Wisconsin Department of Transportation

Proposal #12: 2722-08-71, WISC 2025102
C New Berlin Moorland Road
CTH ES to CTH D
CTH O
Waukesha County

This is Addendum No. 01, which provides for the following:

ADDENDUM NO. 01

SHEET 17

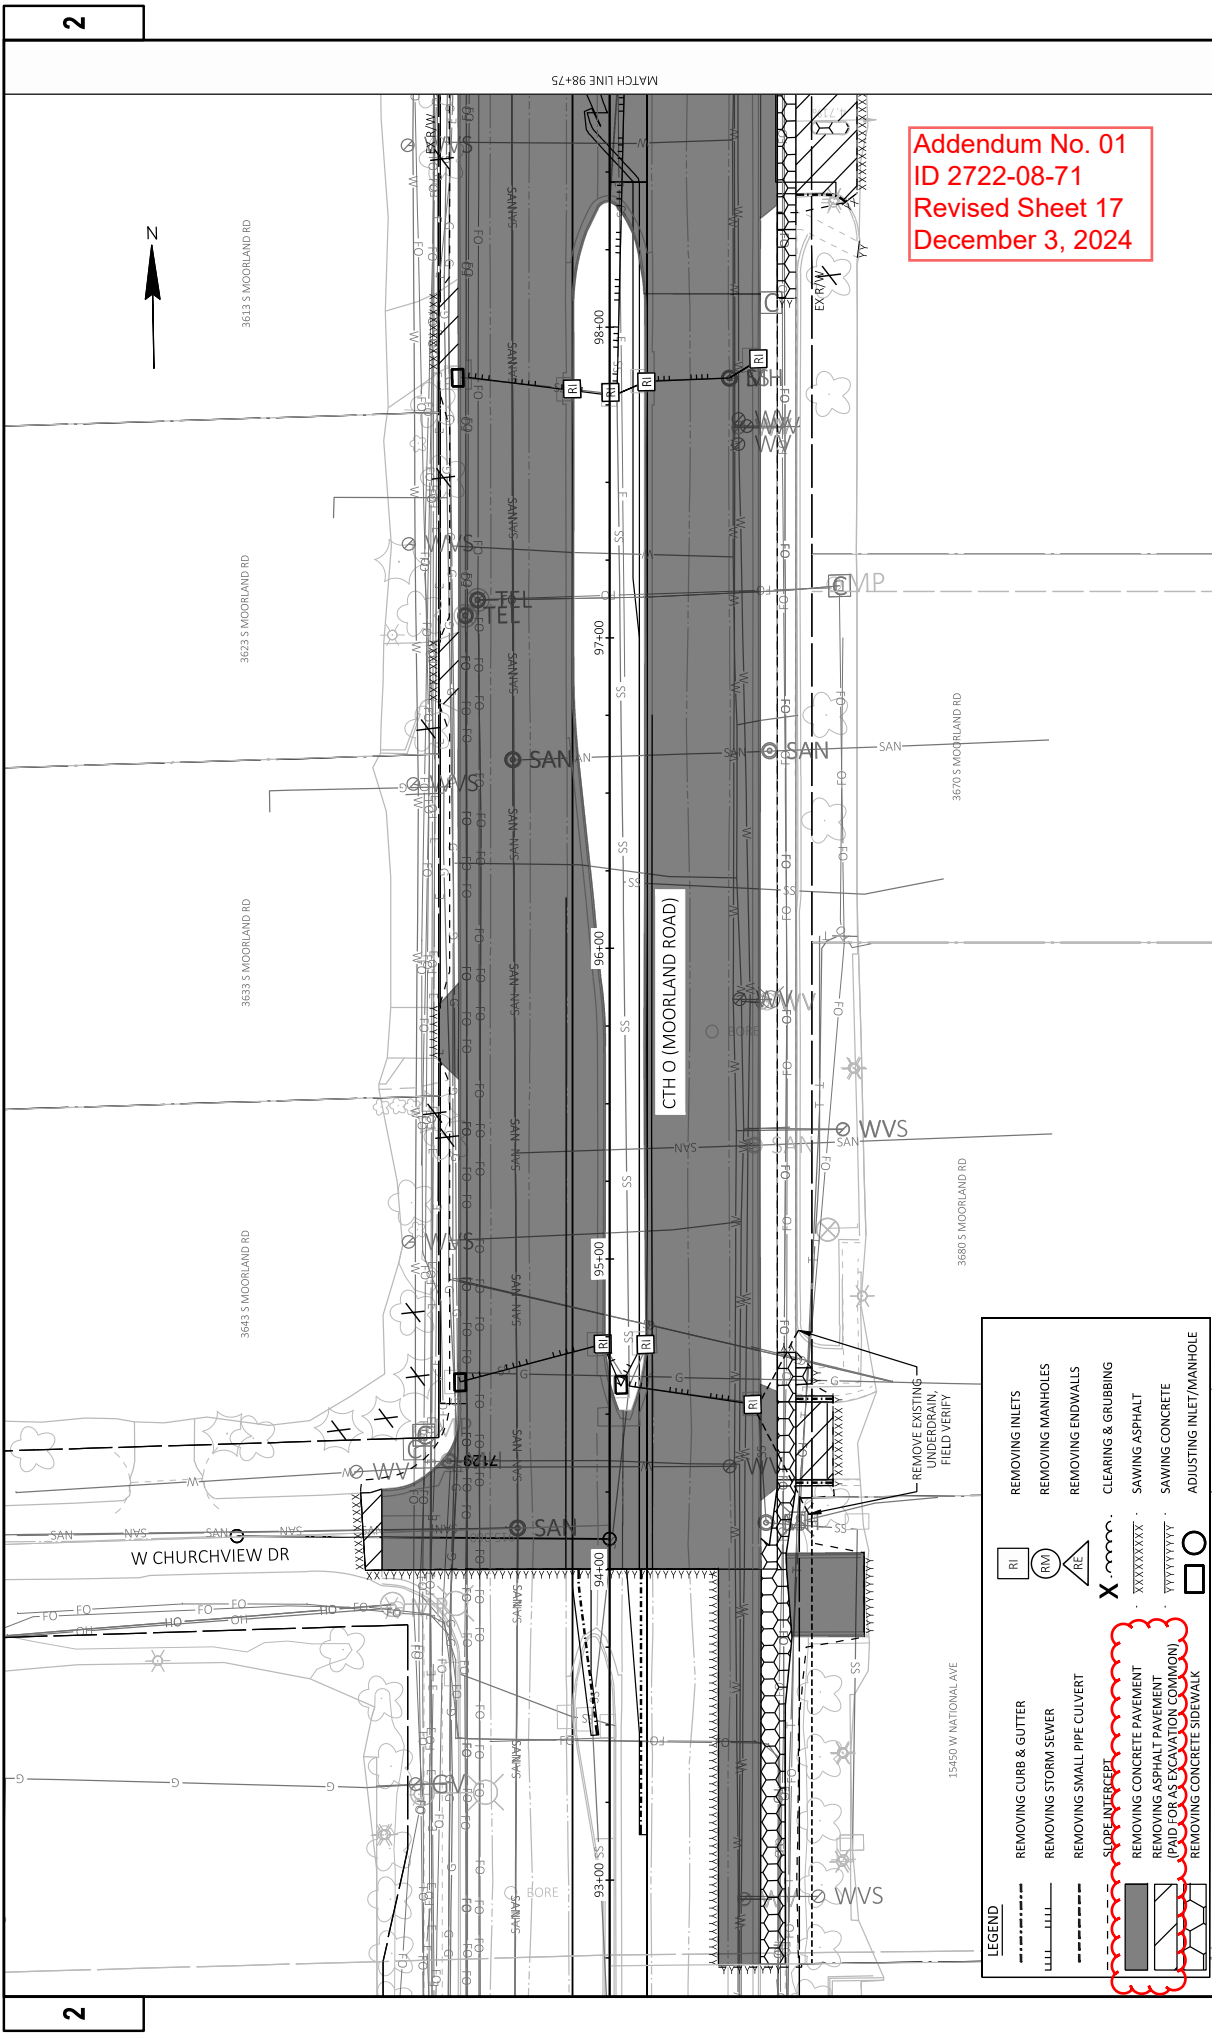
Revised Plan Sheets	
Plan Sheet	Plan Sheet Title (brief description of changes to sheet)
17-27	Removal Plans; Revised legend for clarification; Removed bid item Removing Asphaltic Surface Milling
239	Miscellaneous Quantities; Removed bid item Removing Asphaltic Surface Milling
249	Miscellaneous Quantities; Update bid item Spot Repair Existing Storm Sewer from LF to EACH
